RE: RESPONSE TO INFORMATION REQUEST IN RELATION TO THE PROPOSED RECONFIGURATION OF A LOT ON LAND AT 84-160 CHRISTENSEN ROAD SOUTH, STAPYLTON (COUNCIL REF: ROL201700424)

RE: L334 SP193431 84 - 160 CHRISTENSEN ROAD SOUTH STAPYLTON QLD 4207
PN307555/02/DA9 – DEVELOPMENT APPROVAL
REQUEST FOR INFORMATION RESPONSE

**RE: L334 SP193431 84 - 160 CHRISTENSEN ROAD SOUTH STAPYLTON QLD 4207
PN307555/02/DA9 – DEVELOPMENT APPROVAL
DETENTION BASIN REVIEW**

Drawn K.J.L.	Date 15/09/17	Chkd T.J.S.	Date 15/09/17
Design K.J.L.	Date 15/09/17	Scale AS INDICATED	A1
Project No. 17-209	Dwg. No. DA01	Rev D

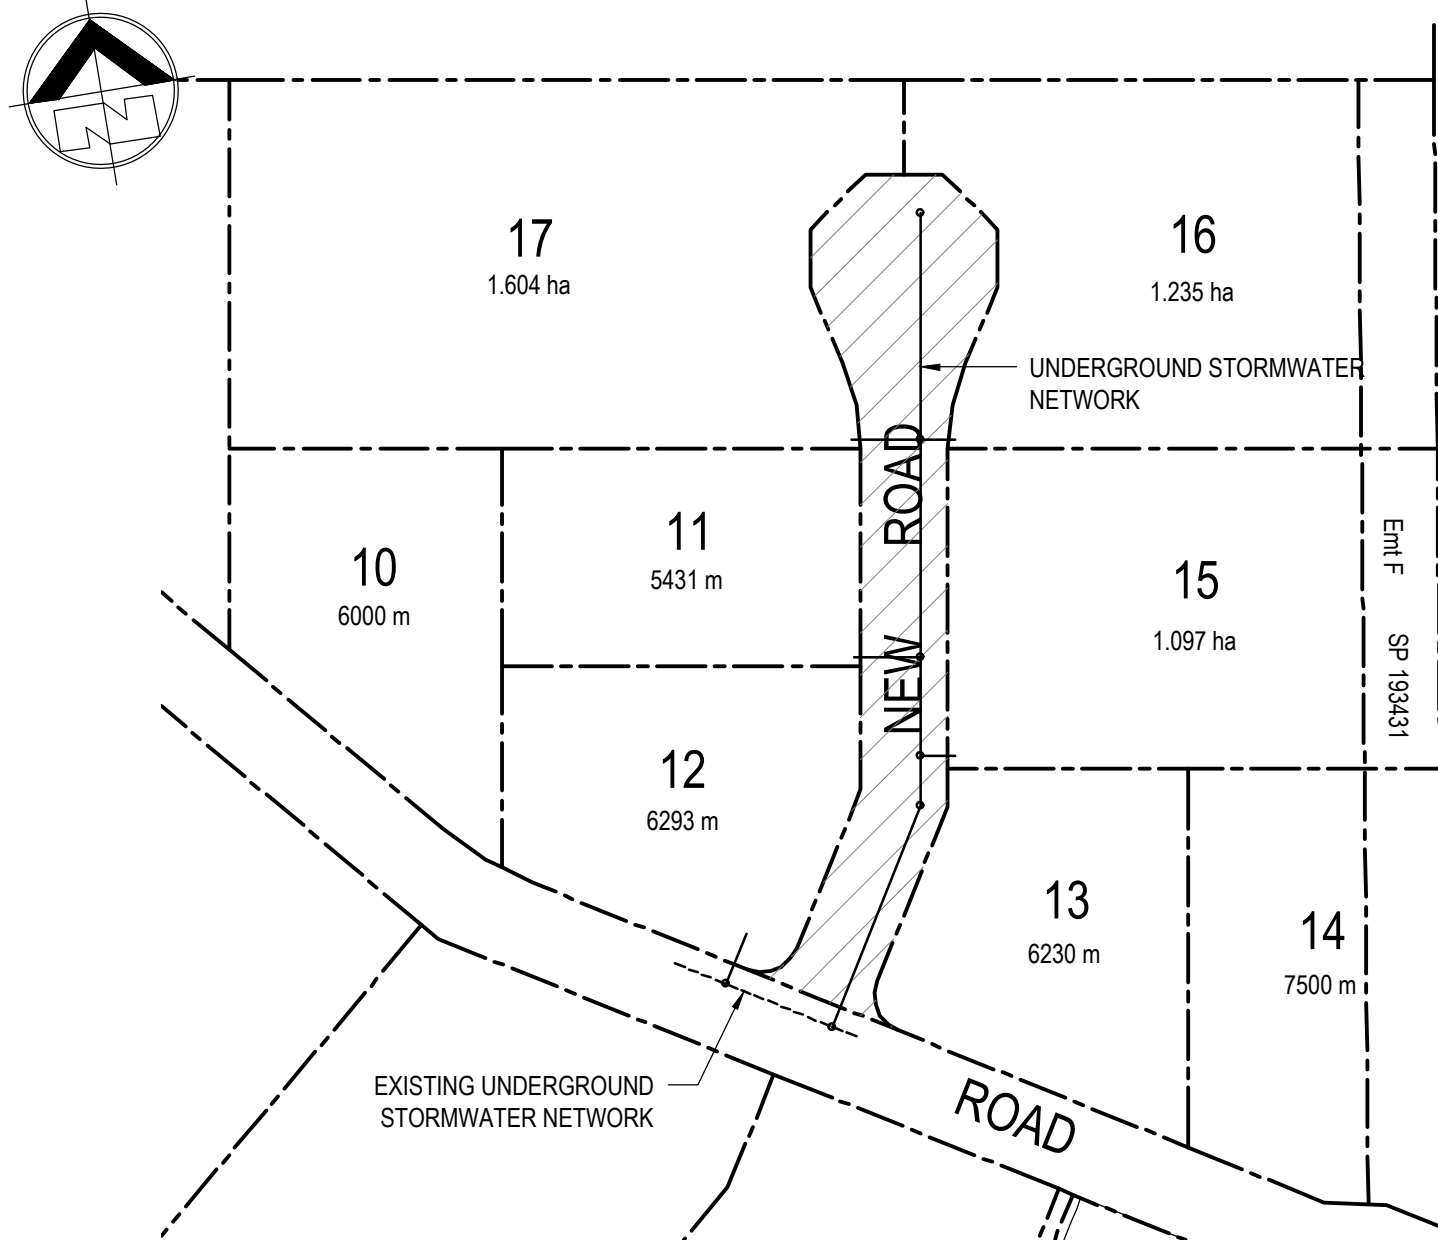
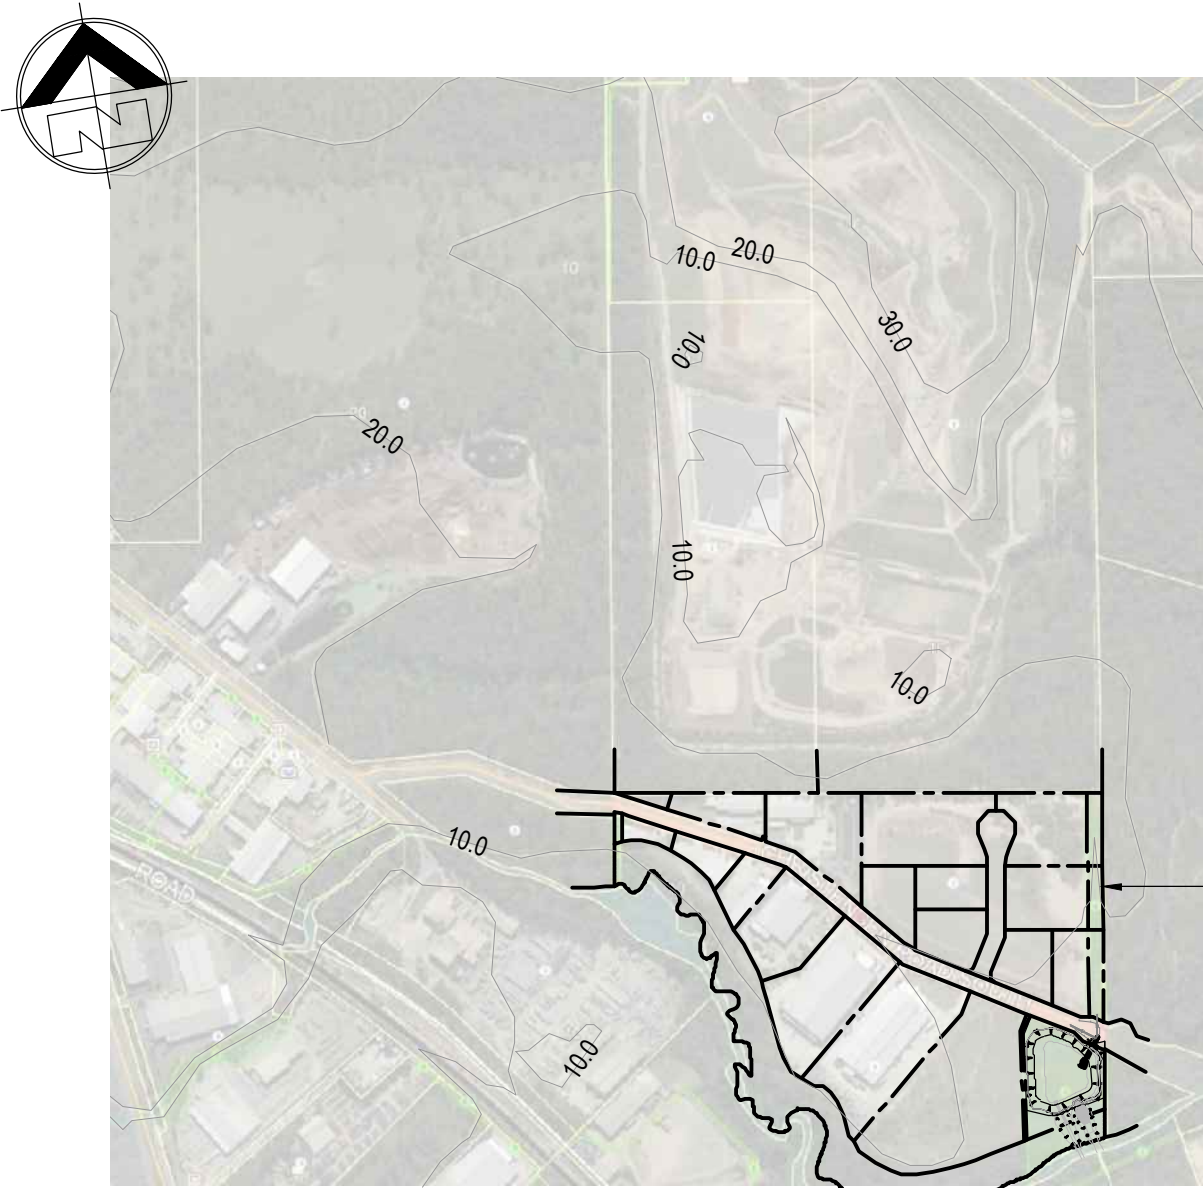
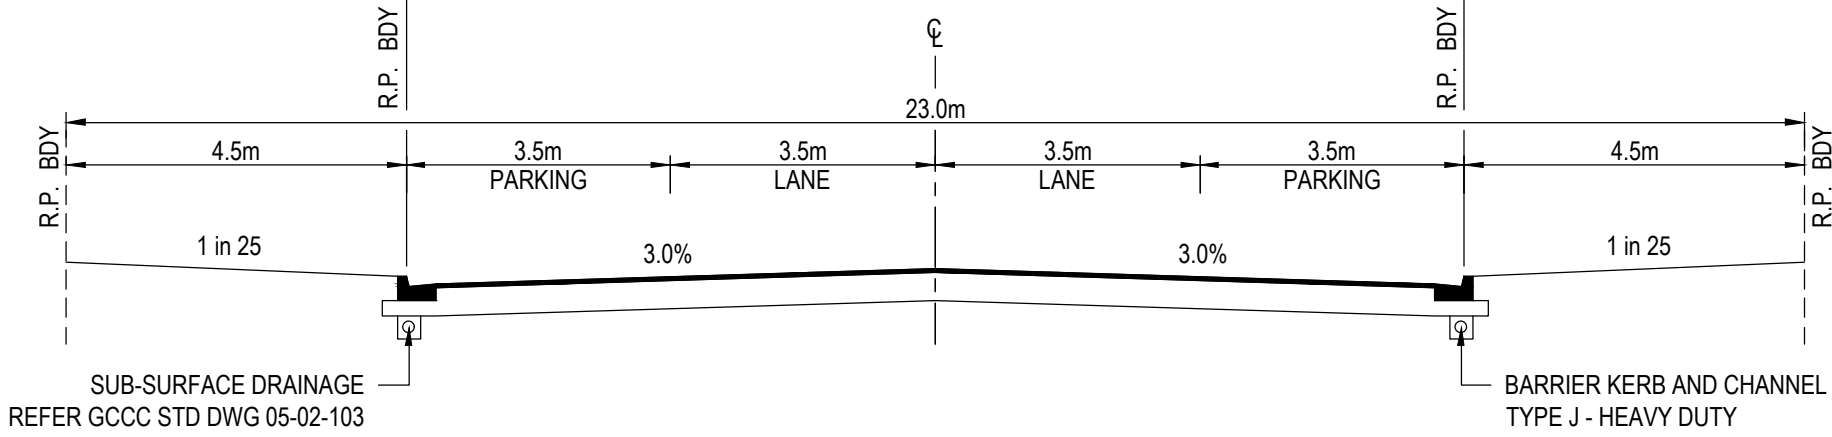
- iv. A drainage layout plan to be included in the report to identify how minor runoff will be connected to lawful point of discharge from each lot and how major flow will be conveyed safely, satisfying QUDM's public safety criteria, to a downstream drainage system.

As requested, please find attached drawing no. DA01 Revision D prepared by iCubed Consulting Pty Ltd which shows the typical cross section for the new road construction as part of Stage 2. In accordance with the original proposal plan prepared by AJS Survey, the road reserve is a minimum of 23m in accordance with Standard Drawing no. 02-001.

For Stage 1 the existing underground network will adequately service the development as there is no intended works. For Stage 2 the proposed lots fronting the new road will be serviced via an underground network running along the new road and connection to the existing network within Christensen Road South. The existing network has been designed to cater for the fully developed catchment. Refer drawing 17-209-DA01 for conceptual layout of the proposed network.

BEV417-C-DWG-014

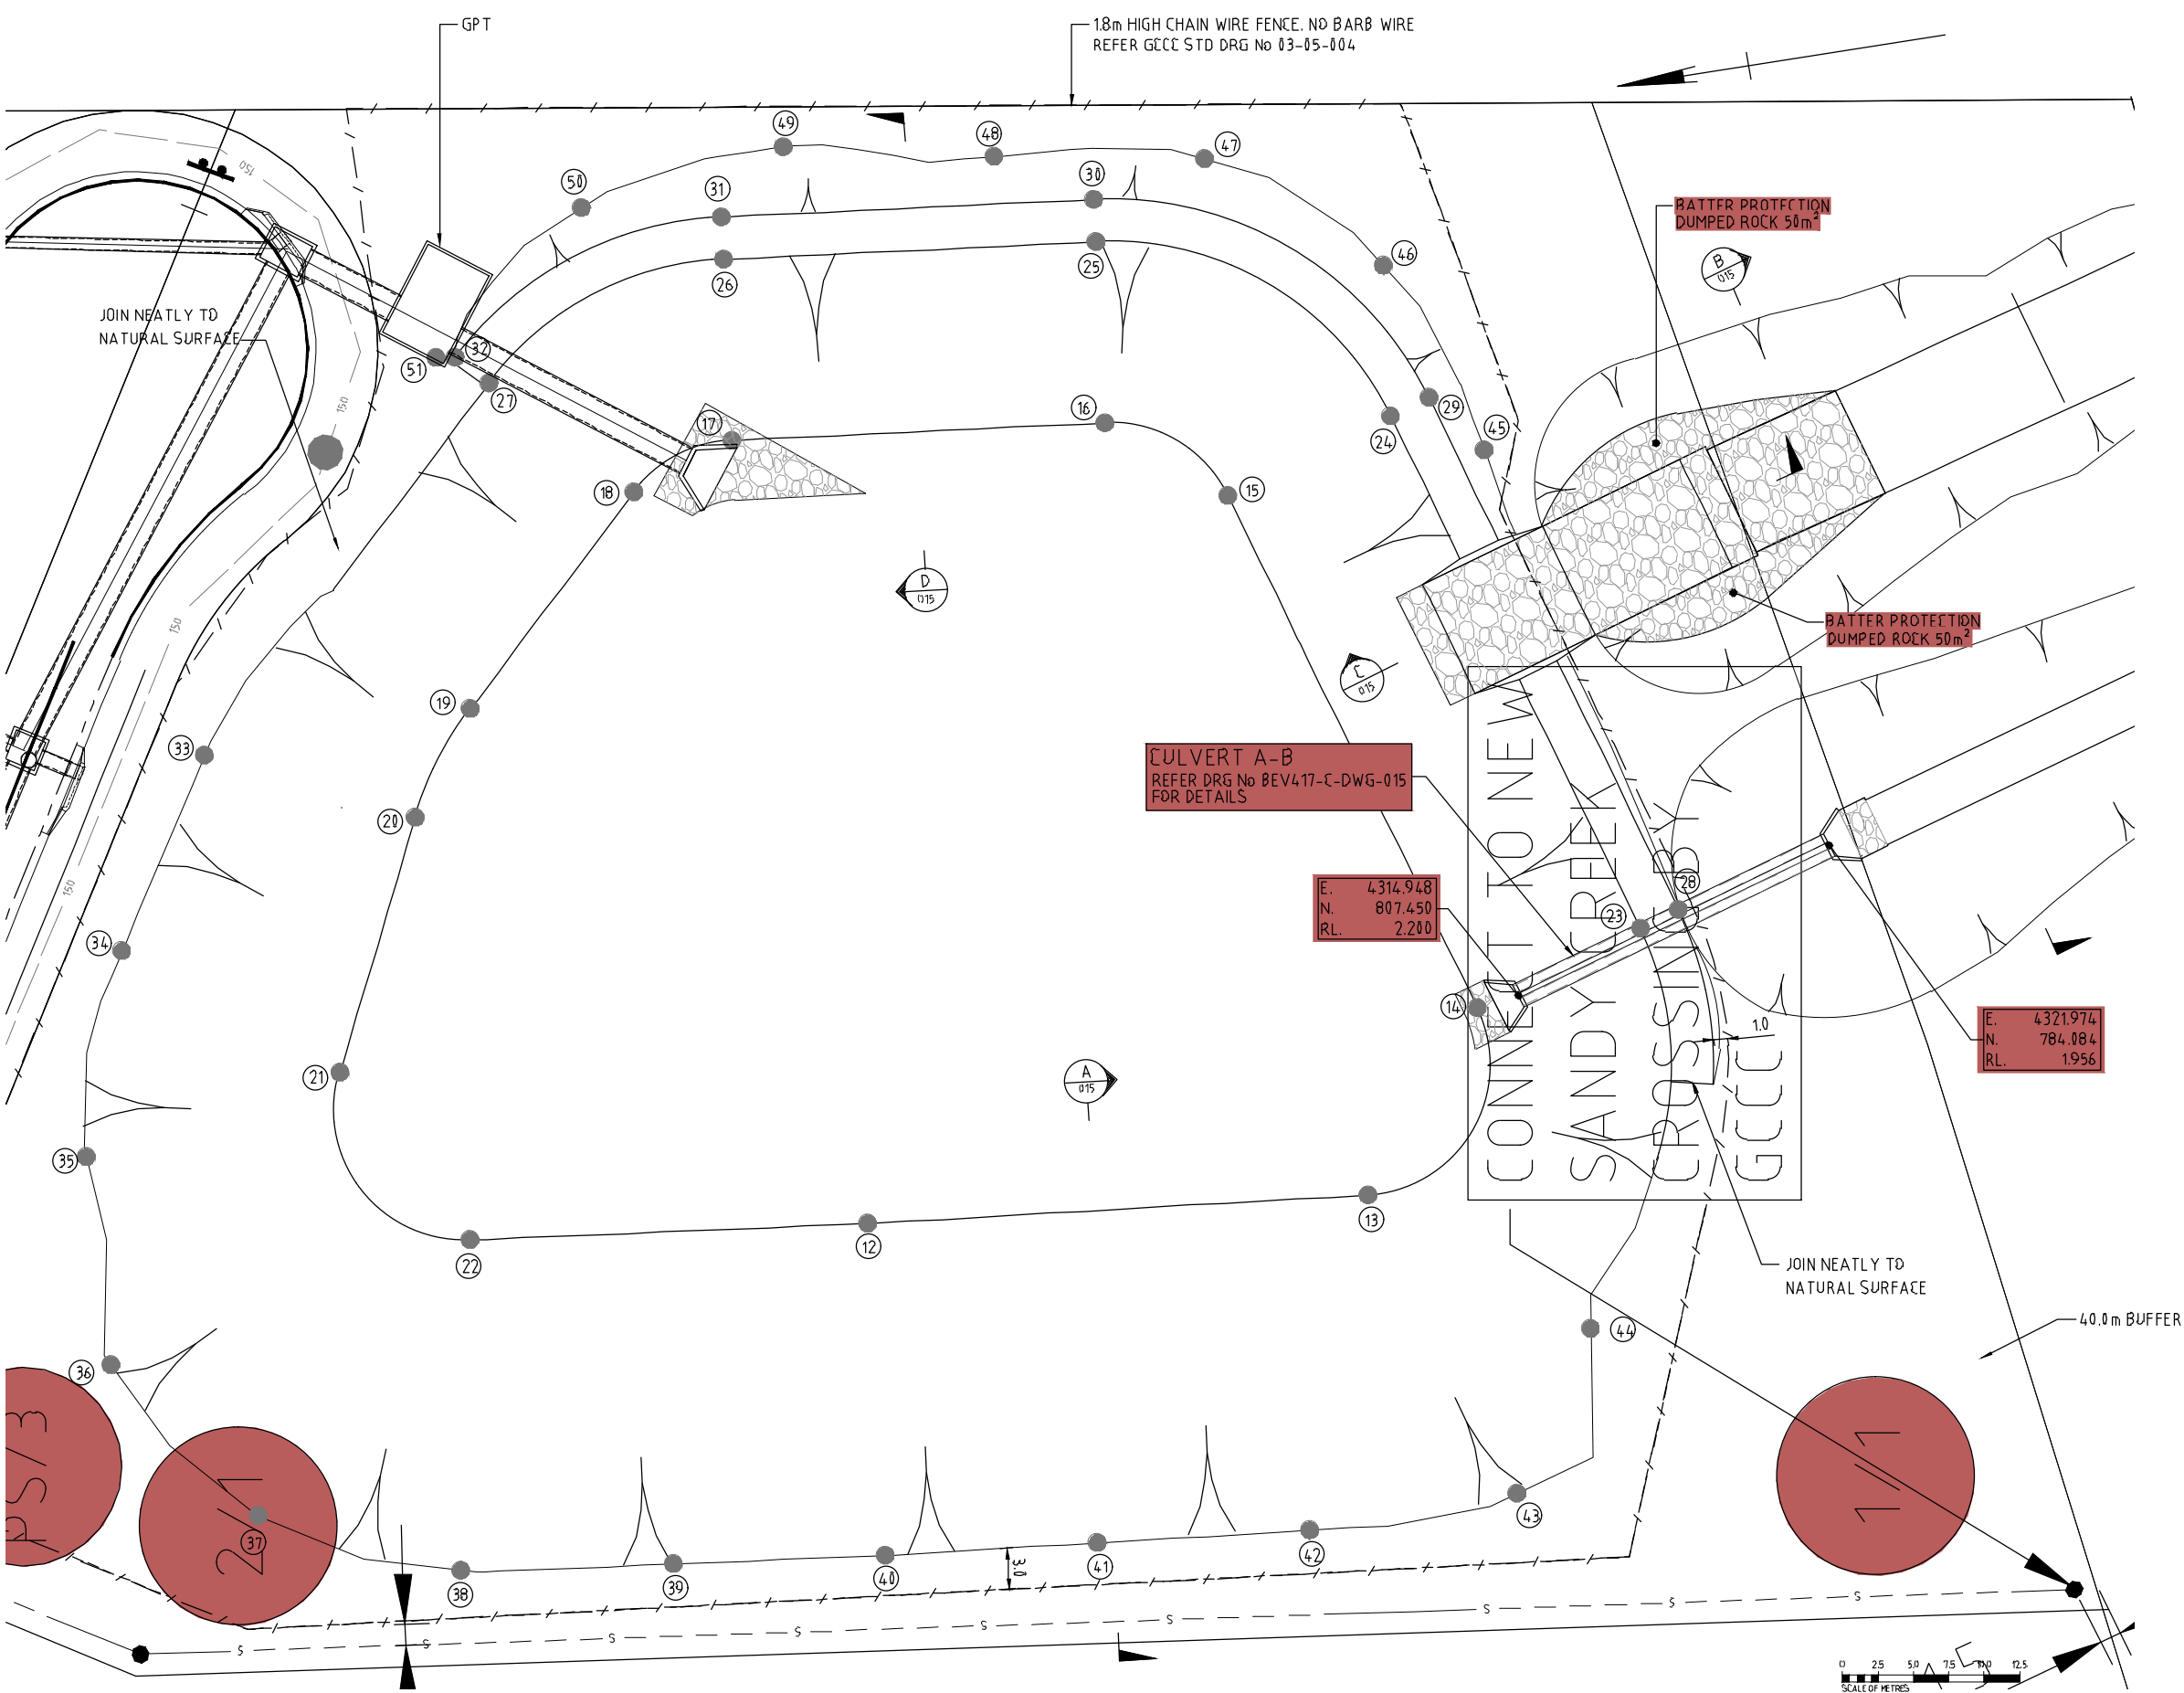
- ii. Therefore the report needs to be amended to include stormwater quantity management issues for the site. If the applicant claims that the existing basin will be functioning for the whole site, a capacity assessment is required to be undertaken to justify that the basin size is adequate to ensure no worsening of stormwater runoff from the whole site for all events up to the 1 in 100 year storm. The report will also include all necessary engineering details of the basin on scaled maps and drawings showing how runoff from the whole site will be directed to the basin. Please also include basin inlet/outlet details, cross sections, etc.

In order to confirm the detention basin has been constructed as per the report, a survey has been carried out and the volume calculated. The survey showed that the basin had been constructed in accordance with the design (drawing BEV417-C-DWG-014 & -015). The inlet and outlet pipes are at the correct heights however there has been some sediment buildup within the base since construction, resulting in a reduction of the capacity to 87% of the initial capacity. This relates to an issue with maintenance and not the design of the basin.

The survey was then compared to the design drawing for the subdivision (Dwg No. BEV417-C-DWG-014 & -015).

The levels for the inlet pipe, outlet pipes and overflow spillway were found to be inline with the design drawings.

The grading of the basin was also inline with the design drawings, however there has been some sediment buildup since construction resulting on a reduction of the basin capacity to 87%. This relates to an issue with maintenance and not the design of the basin.
